Action Transmittal

Action Transmittal: 2024-05

Scope Change Request for Saint Louis Park Cedar Lake Road and Louisiana Avenue Improvements Project

RE: Scope Change Request for SP 163-296-006 & SP 163-296-007

LOUISIANA AVE IMPROVEMENTS - CITY PROJECT NO. 4024-1100

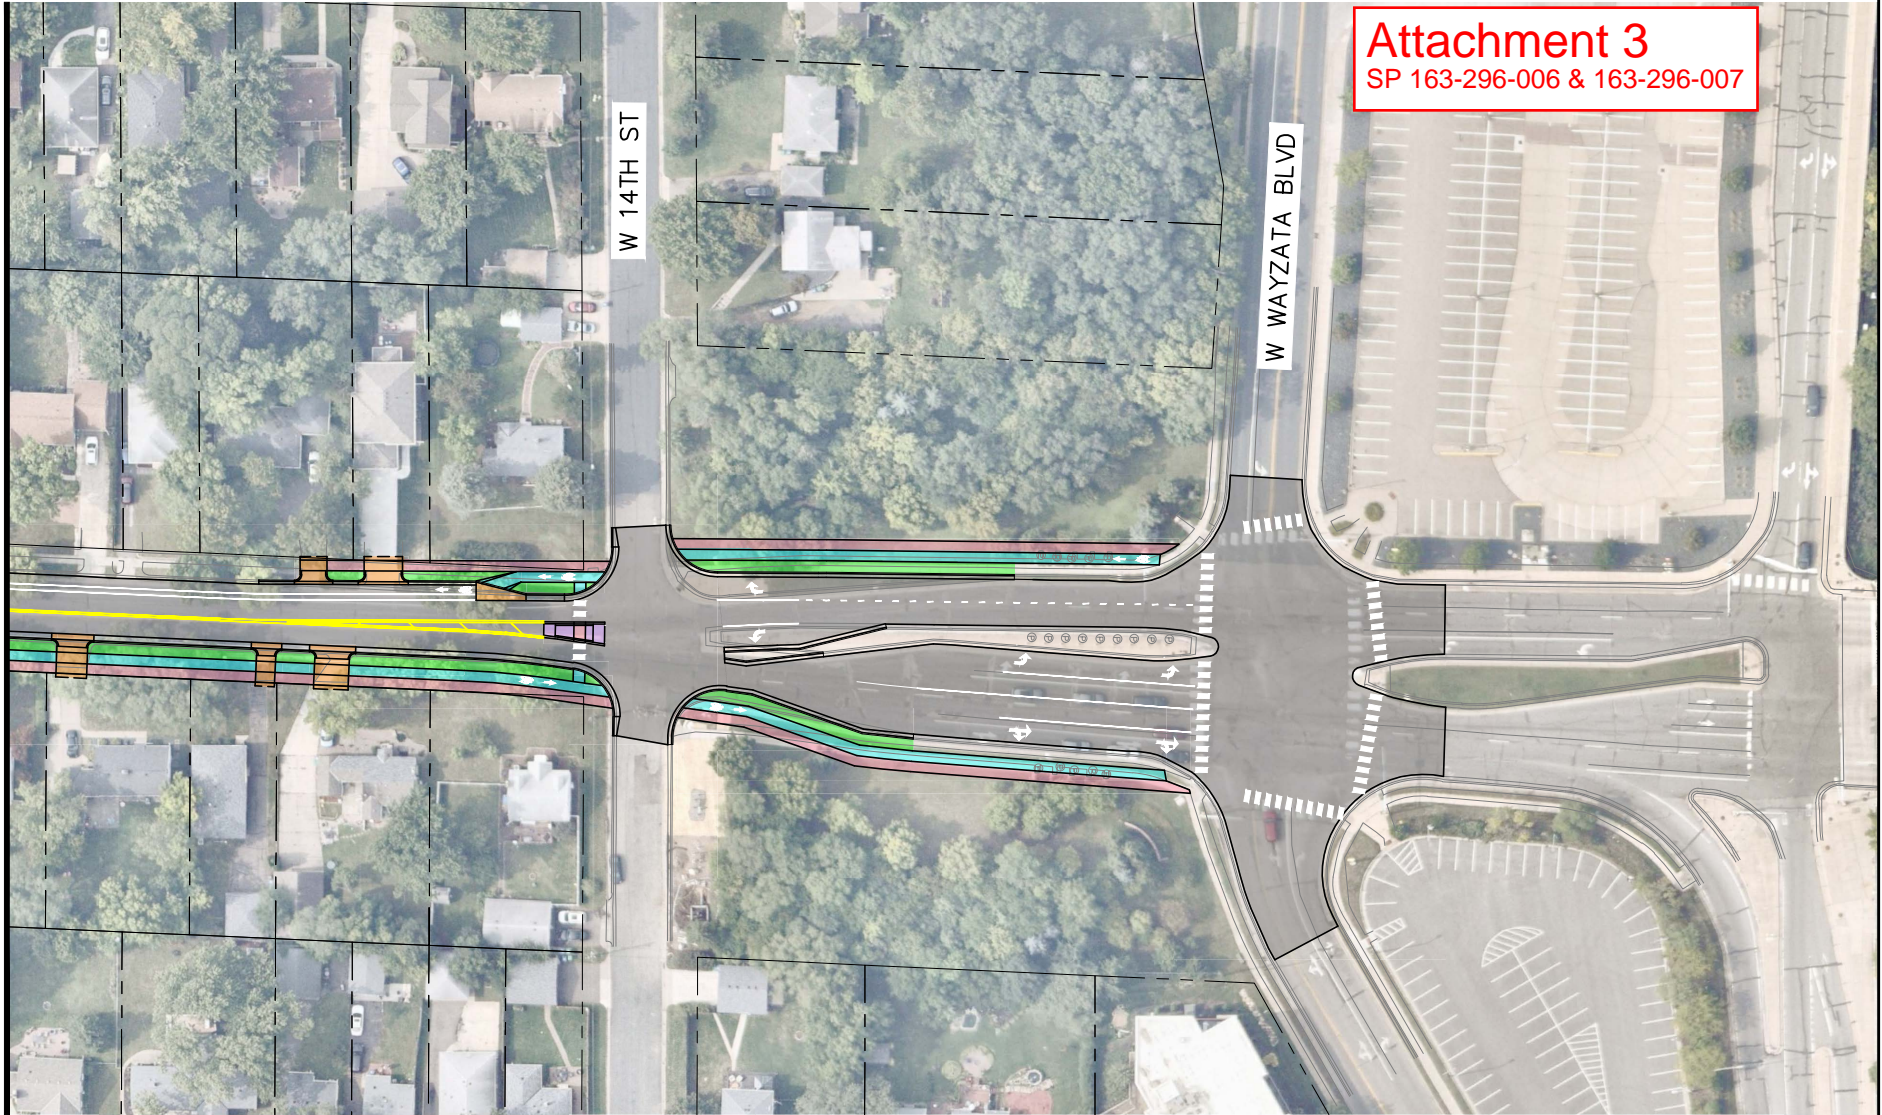
application design. The formal scope change for Louisiana Avenue includes modifying the bicycle facility as described in the table below and shown in Attachment 4 and Attachment 5.

Louisiana Avenue Bicycle Facility Summary		
Location	Funding Application Design	Current Design
Louisiana Avenue: 23rd Street to Cedar Lake Road (400 feet)	Protected one way cycle track in each direction Sidewalk on both sides of the road	Shared use trail on both sides of roadway
Louisiana Avenue: Cedar Lake Road to 22nd Street (900 feet)	Dedicated on street bike lanes or protected one way cycle track in each direction Sidewalk on east side of the road	Shared use trail on west side of roadway Sidewalk on east side of the road
Louisiana Avenue: 22nd Street to 14th Street (2500 feet)	Dedicated on street bike lanes or protected one way cycle track in each direction Sidewalk on east side of the road	*Dedicated bike routes using parallel side streets and trail Sidewalk on east side of the road
Louisiana Avenue: 14th Street to Wayzata Blvd (300 feet)	Protected one way cycle track in each direction Sidewalk on east side of the road	Shared use trail on both sides of roadway

ALTERNATIVE BIKE ROUTE MAP

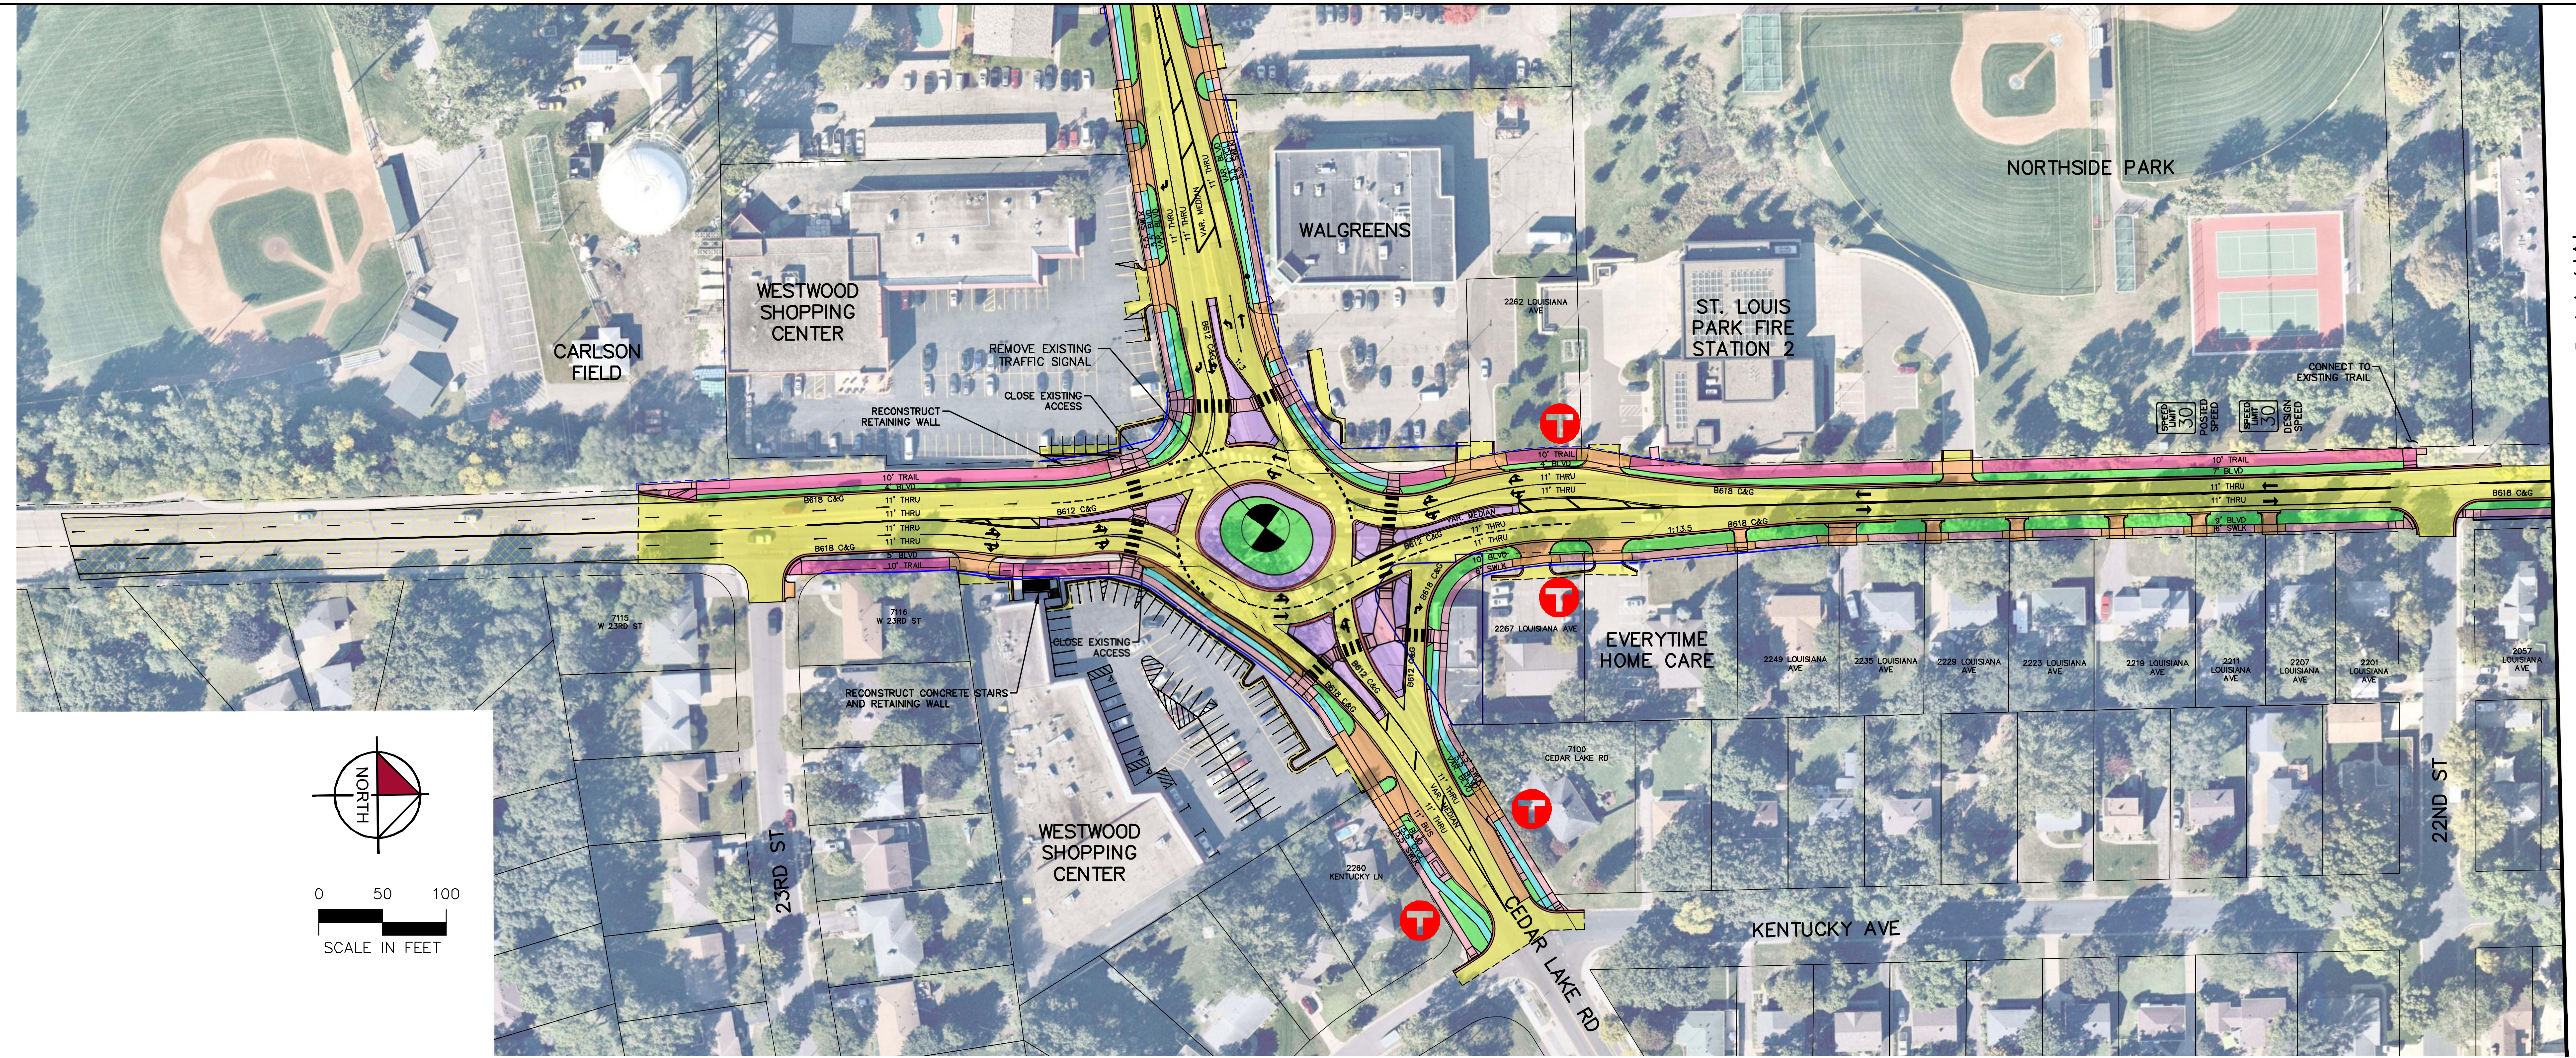
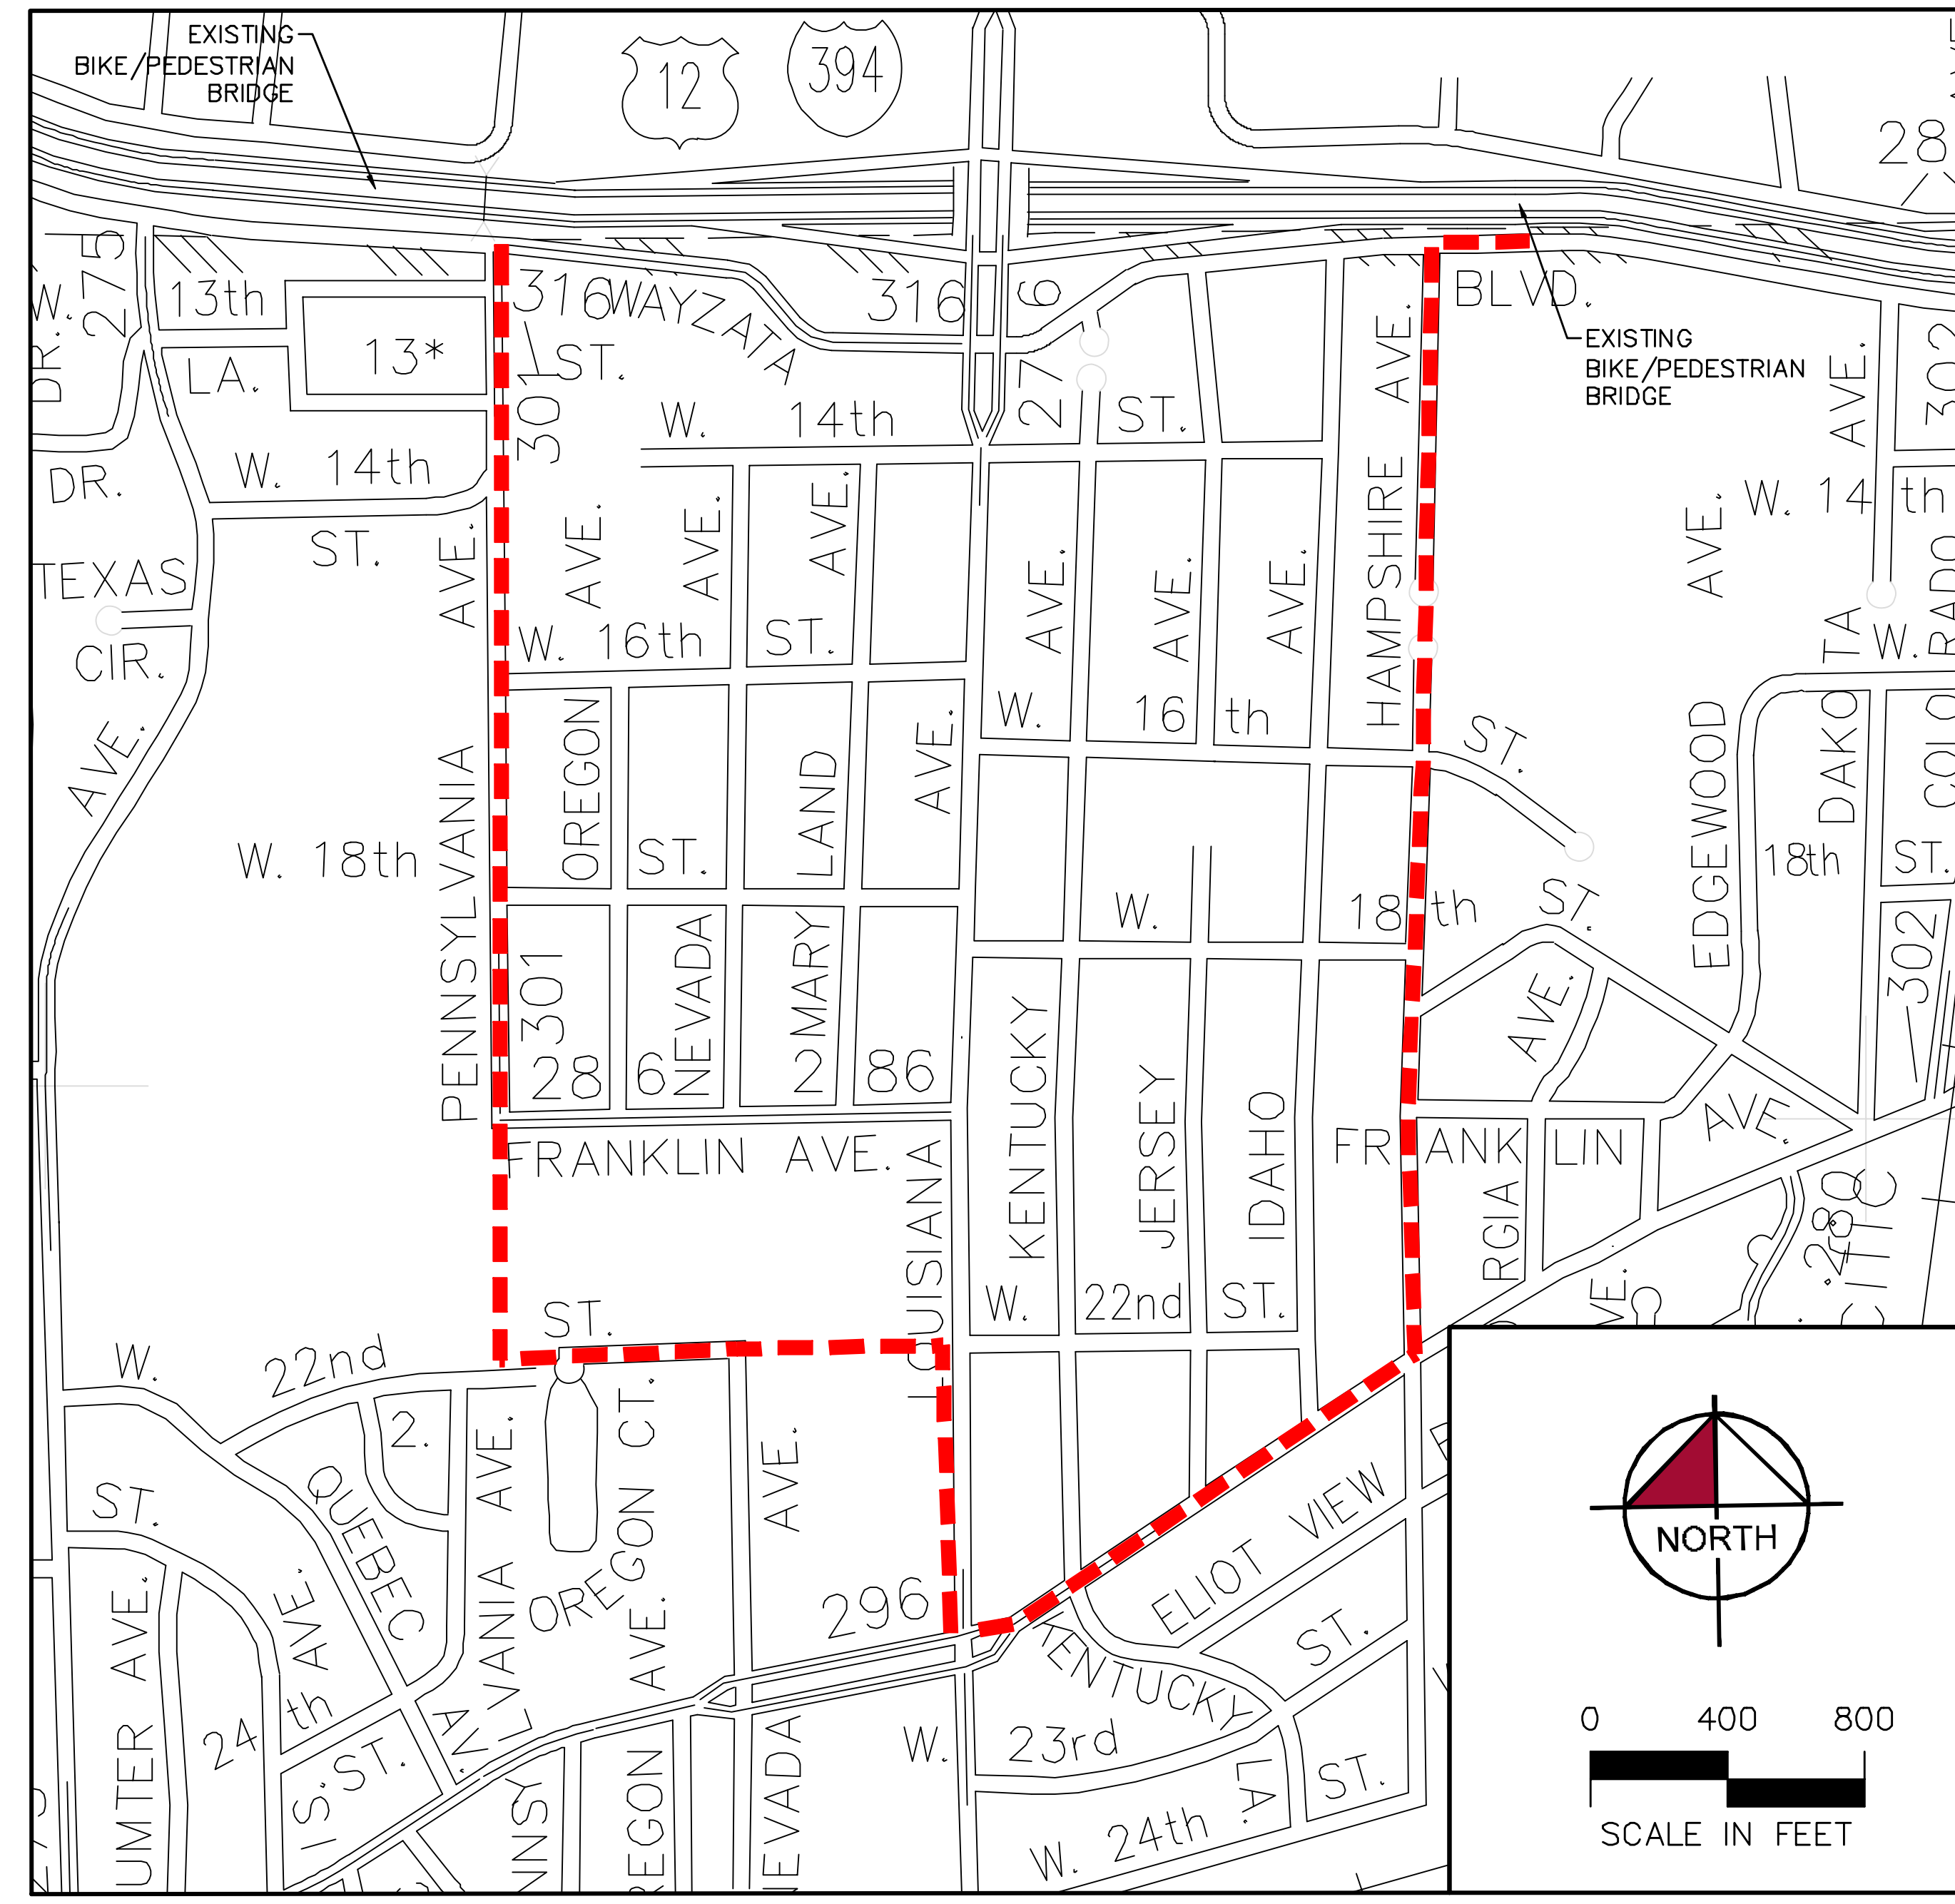
*Dedicated bike routes on parallel side streets include Hampshire Avenue, approximately 1300 feet (4 blocks) east of Louisiana Avenue and Pennsylvania Avenue, approximately 1350 feet (4 blocks) west of Louisiana Avenue. These alternate bike routes are shown as red dashes in Attachment 5 on the "Alternative Bike Route Map".
